DART Kneel Sensor Removal

Property name and Top bus number: DART 304500 - 306500

Issue: Kneel sensor is hitting the wheelchair ramp and getting bent.

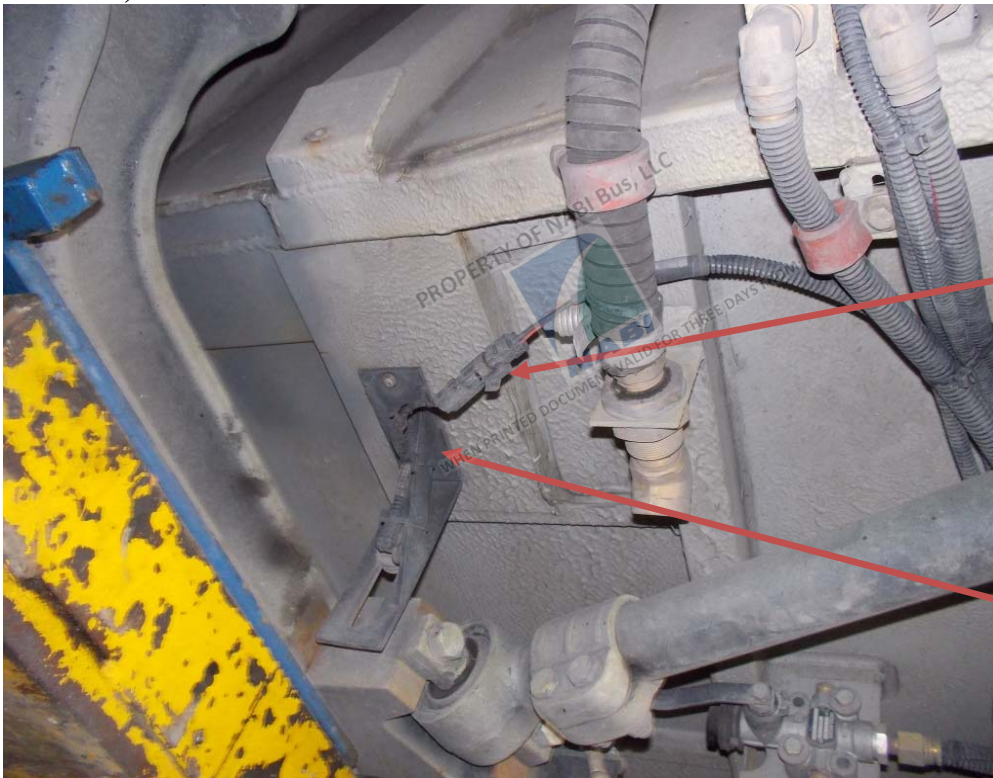
Reason/ cause: Kneel sensor in hitting the ramp.

Solution: Remove the kneeling sensor and the bracket.

1. Park the bus and apply the parking brake.
2. Turn off main battery disconnect switch(es)
3. Under the center of the bus at the leveling valve. Unplug the 2 pin weather pack connector going to the sensor and plug in the 2 pin connector with the dummy plugs installed. Remove the bracket that holds the sensor to the bus by removing the two screws.
4. Reprogram the bus with the MBC programmer using rev L and add the label the MBC with the rev. level date, and tec. initial.

Connector to be removed and 2 pin dummy plug added

Two screws to be removed and bracket to be removed

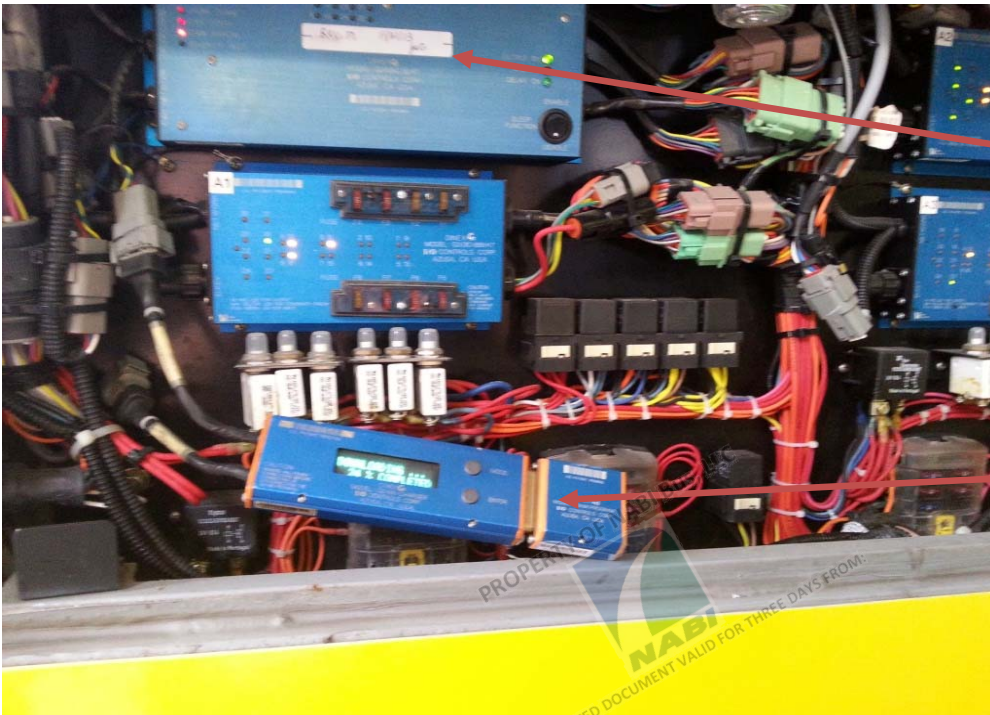
Label to be added

MBC programme
